Addendum #2

**The Parkside Neighborhood Center
and Affordable Housing
Mellen & Grant Streets,
Portland, Maine 04101**

February 20,2004

SKA-12
2/19/04
PARTIAL A5.2

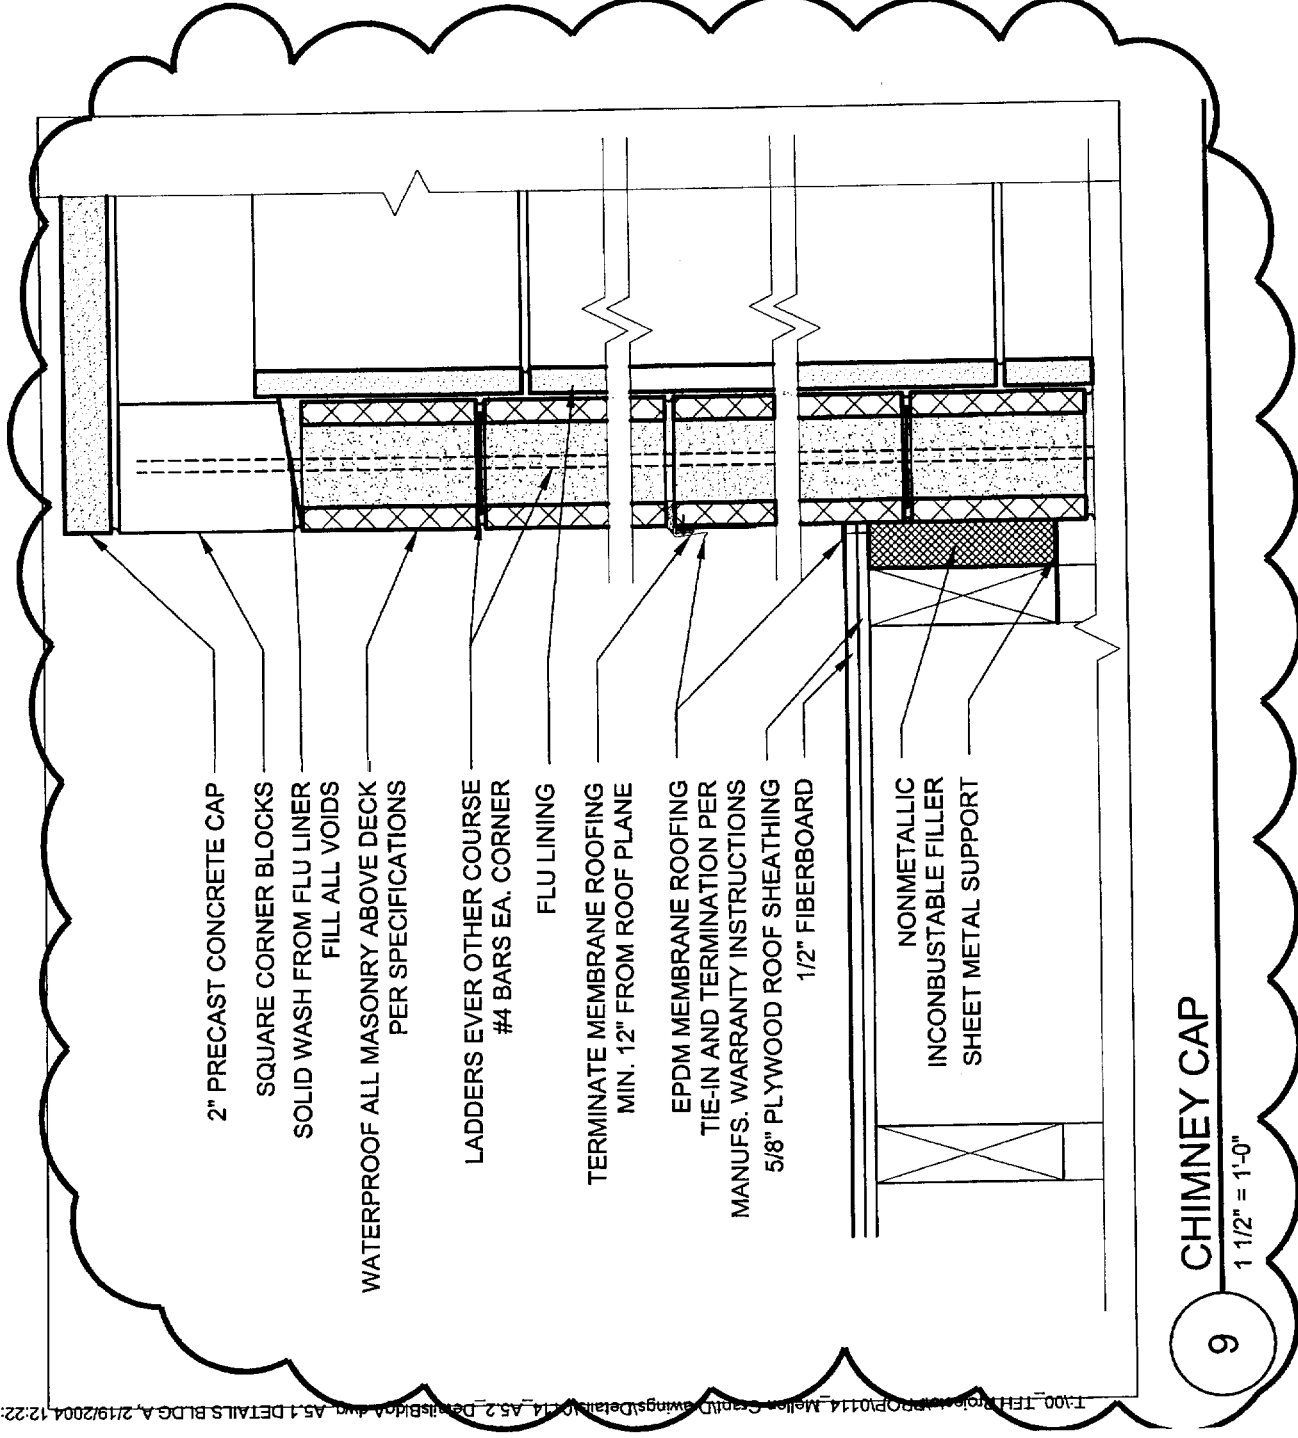
Item	Sheet	Detail	Description
2-12	SKA-12	-	ADD SKA-12, detail 9 to sheet A5.2

What are the requirements for the chimney cap? Any details?

Please see attached sketch SKA-12.

REVISED
SKA-11

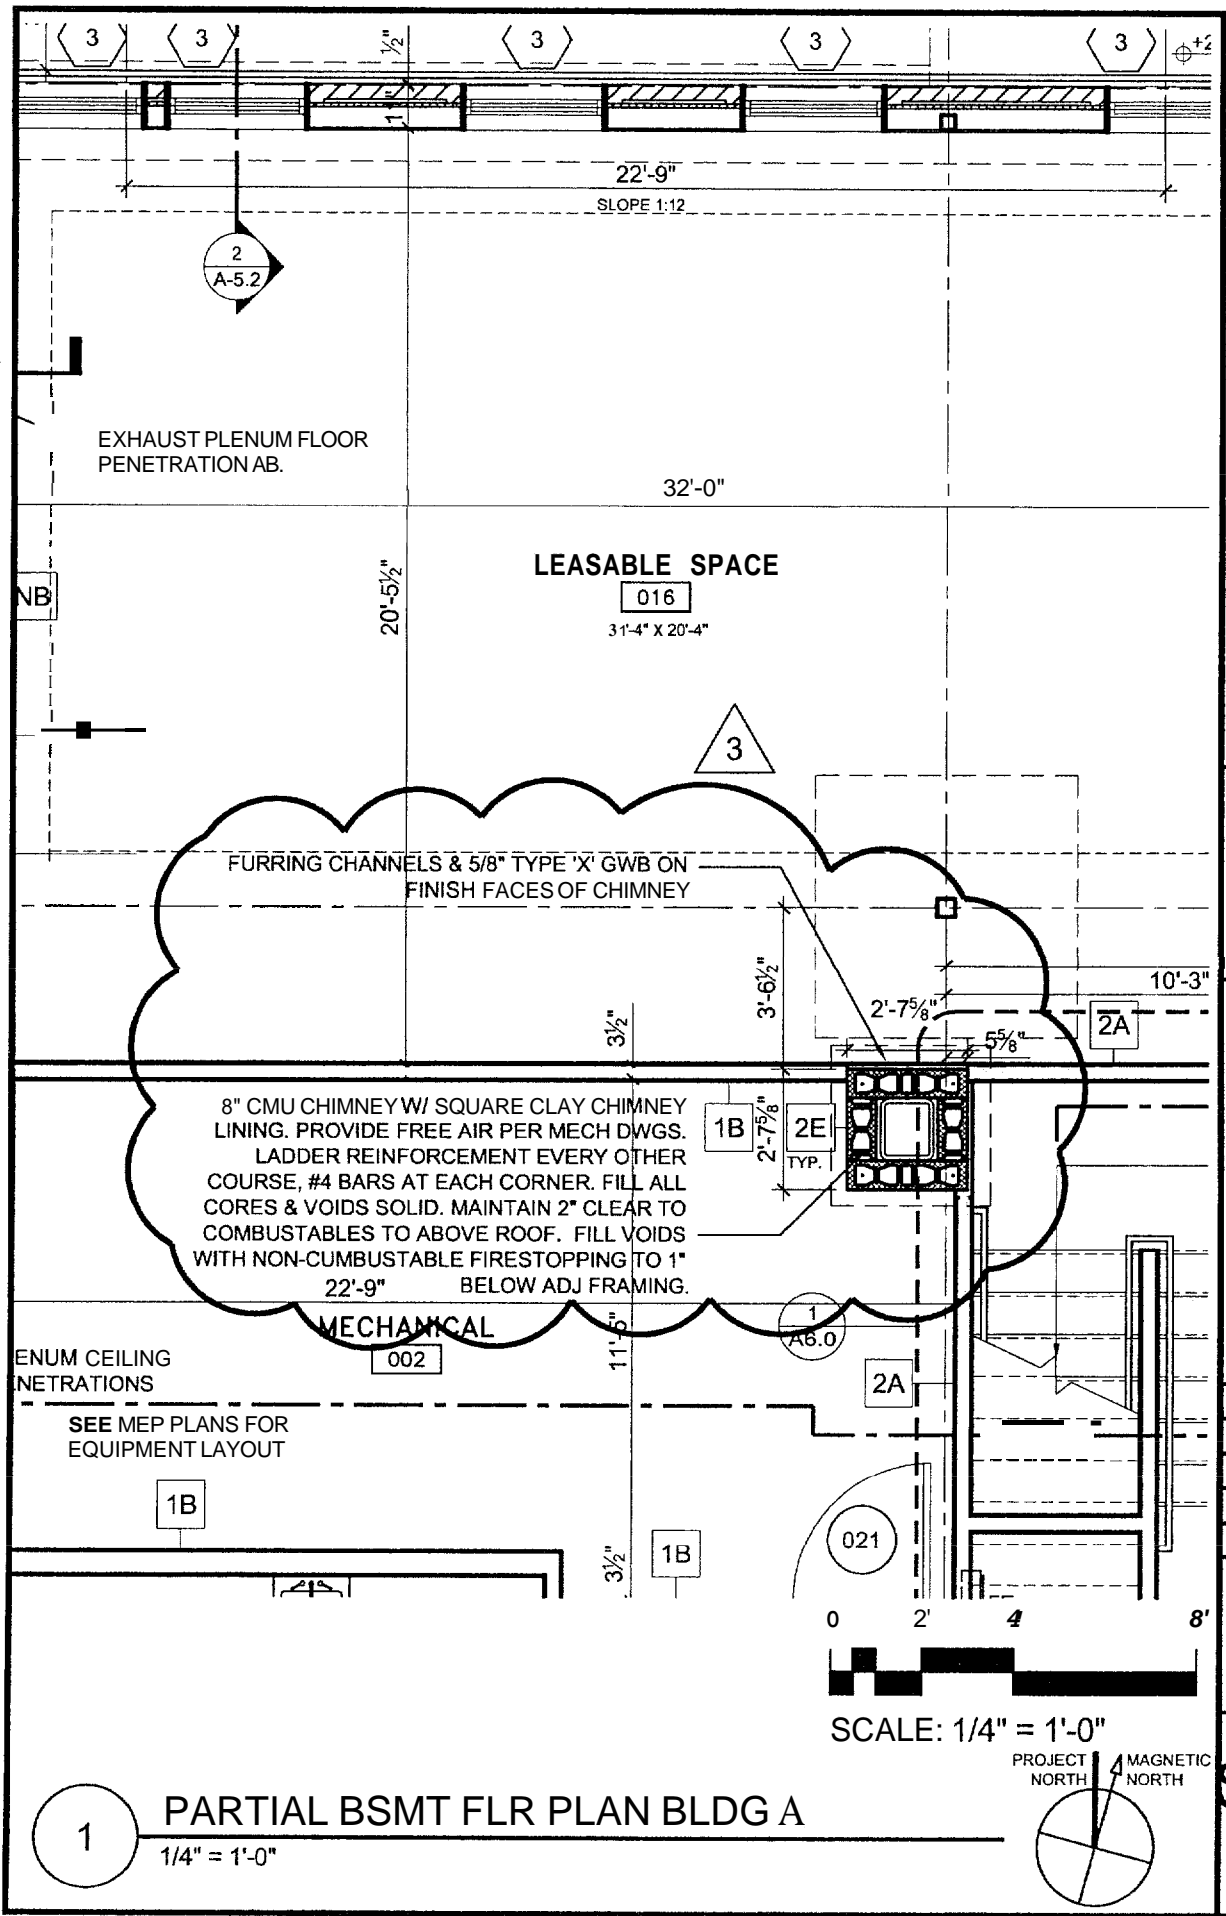
- 3-8 G-1 Partition Types REVISE 2 hr partition type '2E' to 8" CMU.
- 3-9 A1.0 A 1 REVISE chimney with attached revised SKA-11.

SKA-12
 rev. 2/25/04
 PARTIAL A5.2

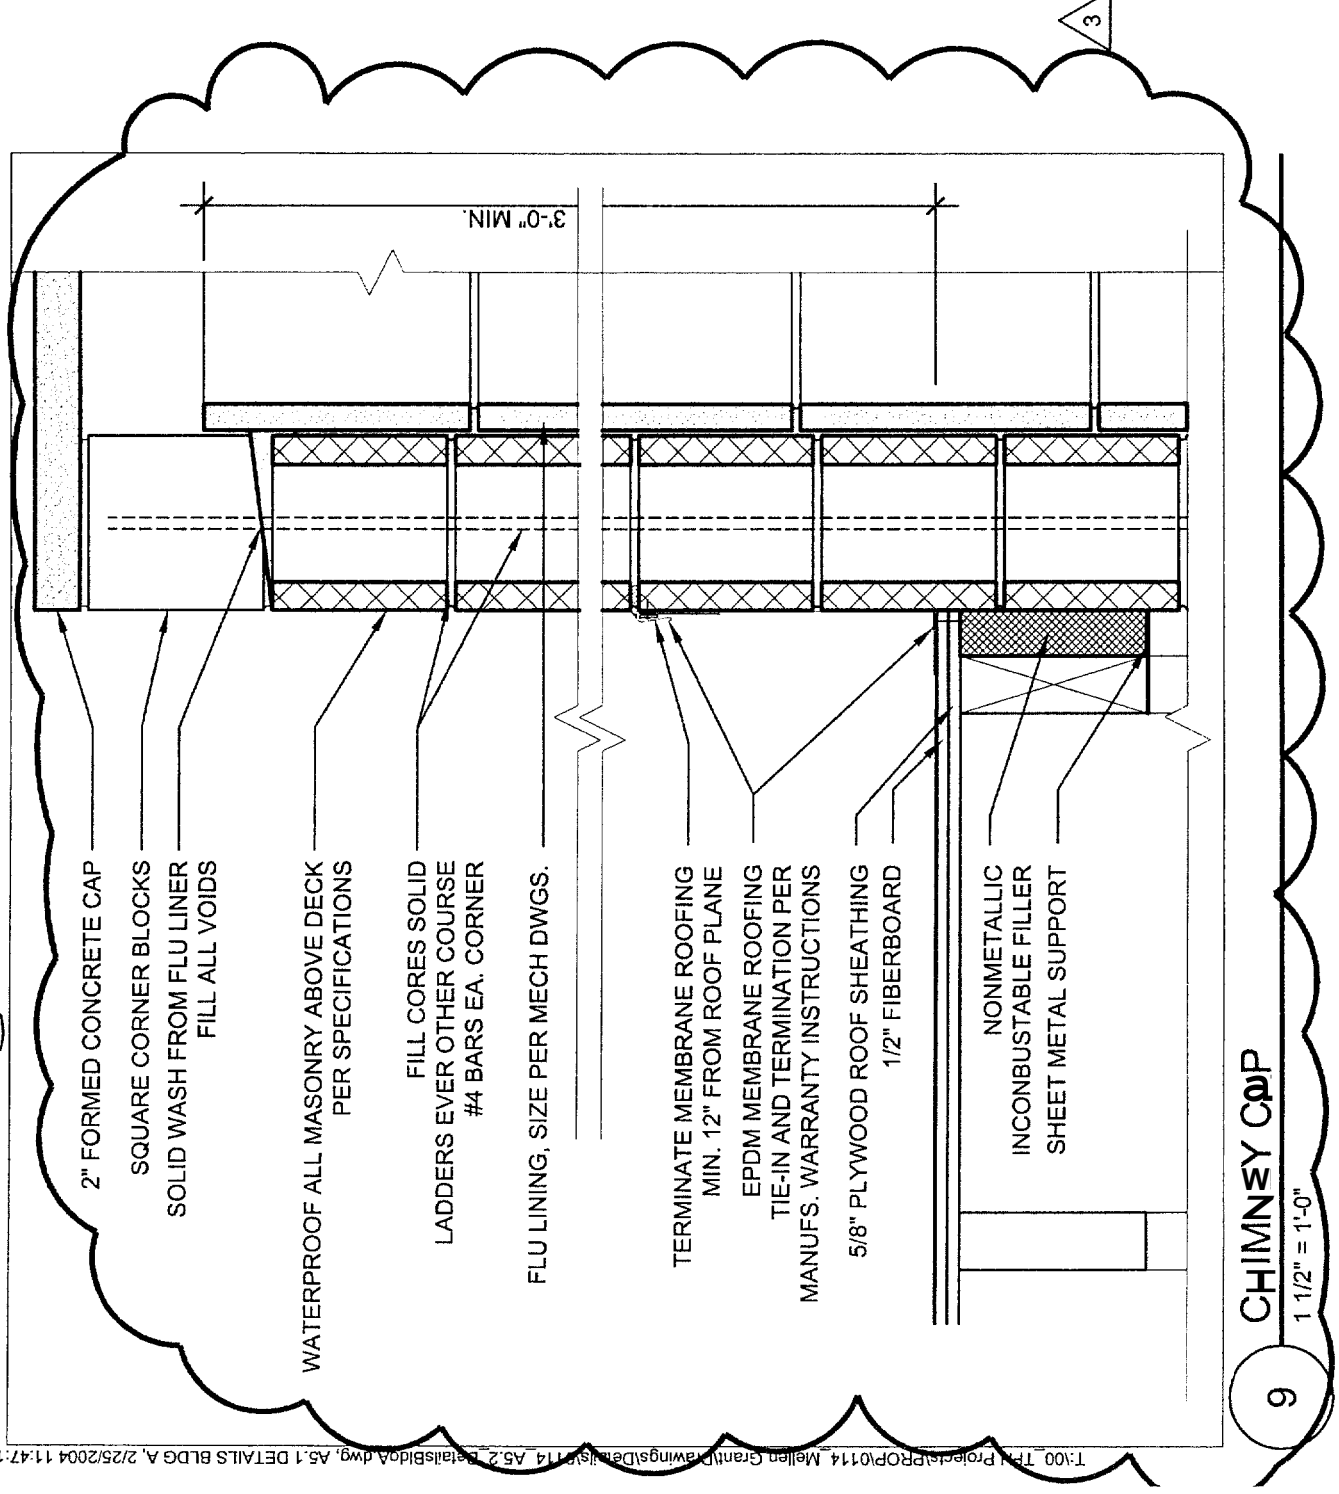
3-10	A1.1 A	1	REVISE chimney with attached revised SKA-13.
3-11	A1.0 B	1	REVISE chimney with attached revised SKA-14.
3-12	A1.1 B	1	REVISE chimney with attached revised SKA-15.
3-13	A5.2 A/B	1	REVISE chimney cap with attached revised SKA-15.
